DEVELOPMENT REVIEW COMMITTEE (DRC) COMMENT REPORT

PROJECT NAME: 3000 Alhambra

CASE NUMBER: R18025

REQUEST: Site Plan Level IV Review: 311 Multifamily Residential Units and 15,000 Square Feet of Retail / Restaurant Use

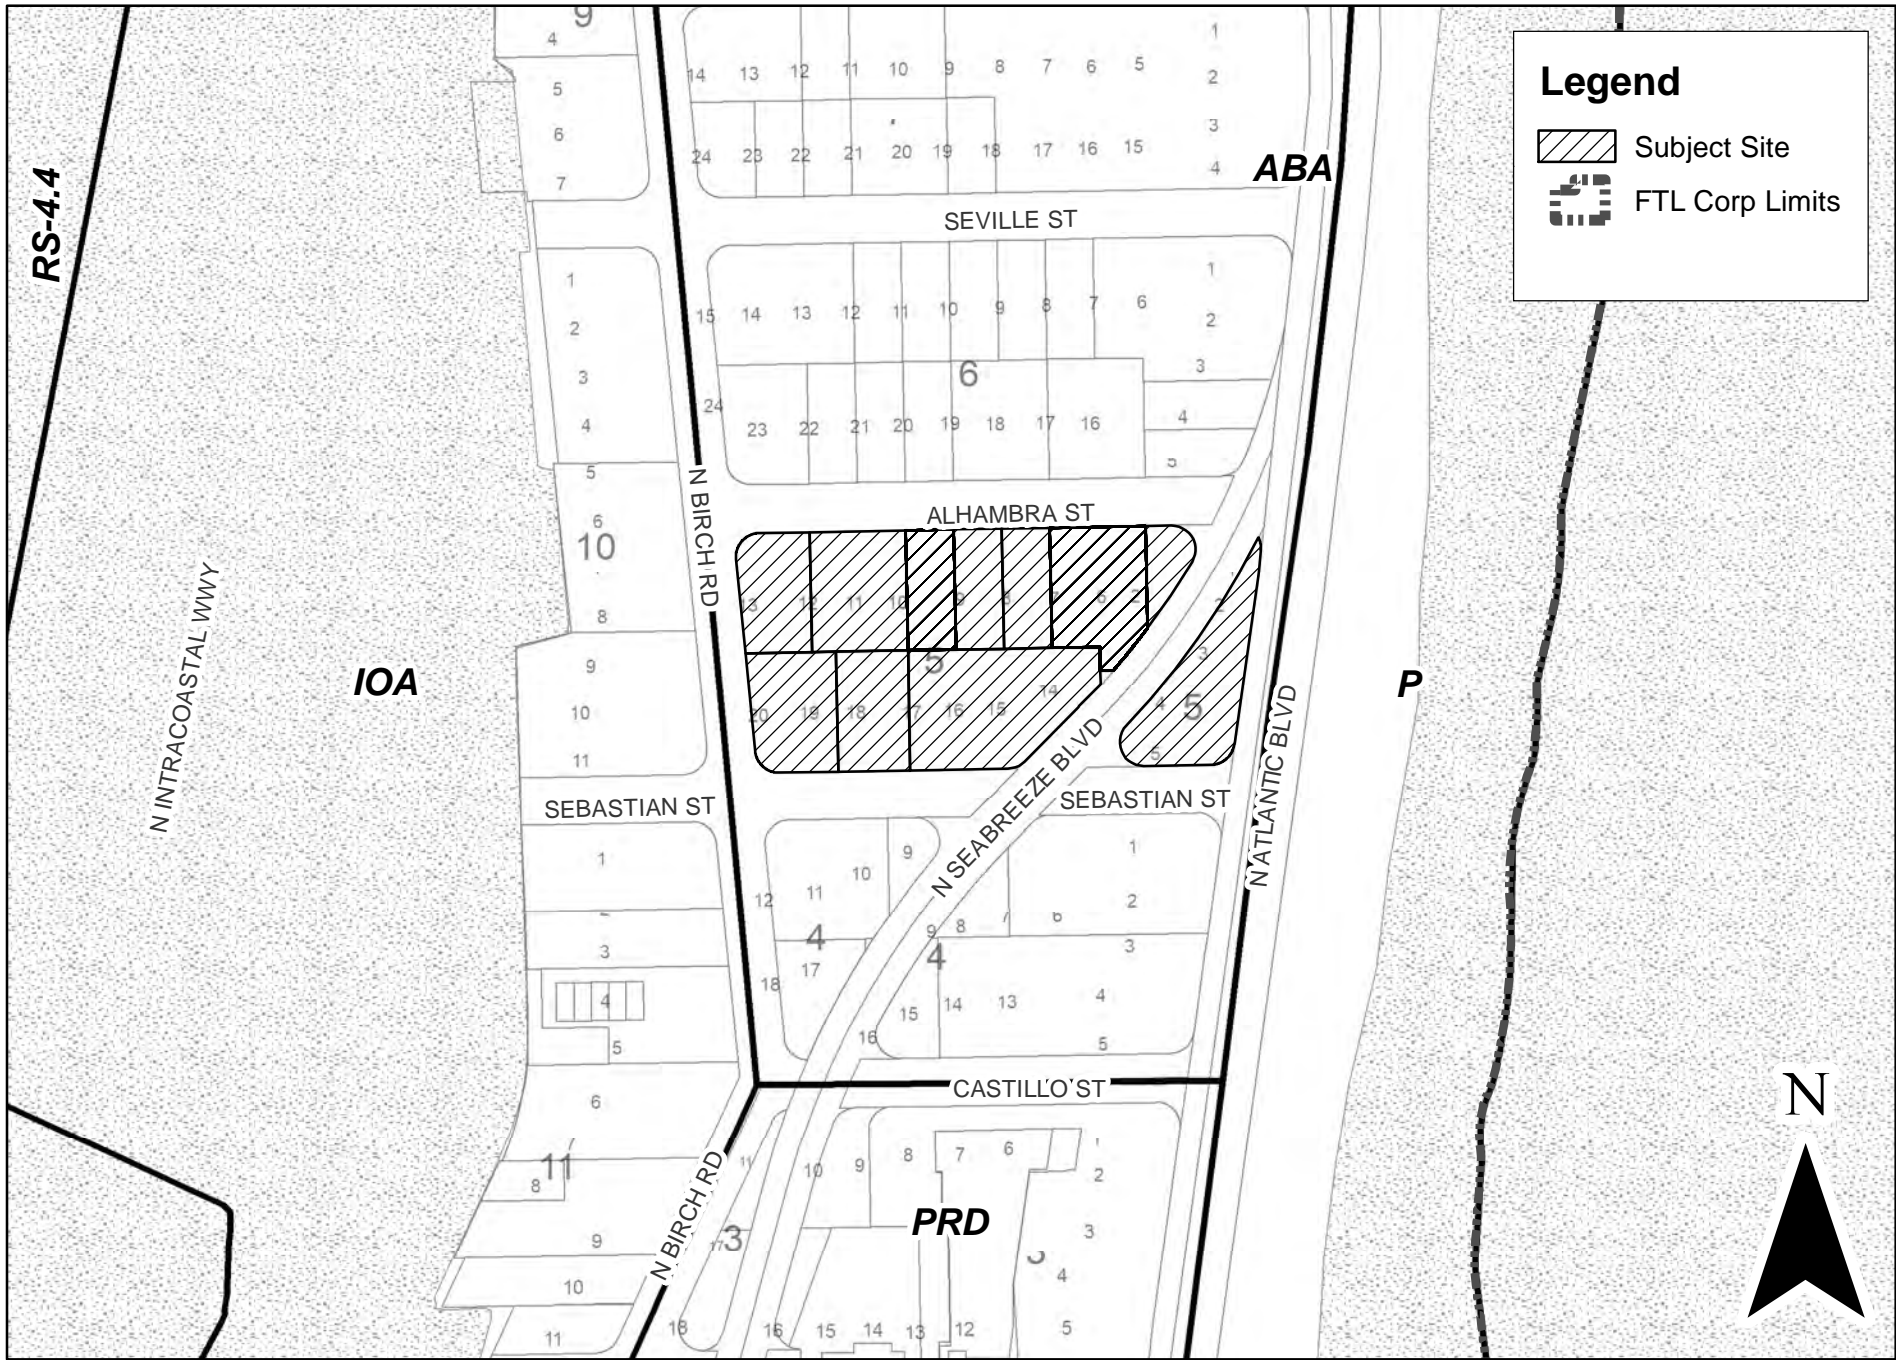
16. The City owns and maintains stormwater infrastructure adjacent to the proposed development as shown with green line work in the map provided at the end of this report. The following comments pertain to possible impacts of the proposed development and/or construction activities to the existing condition of the City's stormwater assets. The applicant shall provide an itemized response letter addressing the following comments:

- 1) Contractor shall provide CCTV videotapes to City STW OPS of the existing stormwater system to the limits shown in the Existing Stormwater Asset Map (green linework) provided in the DRC case comments, in order to document the PRE and POST construction conditions of the City's storm system.
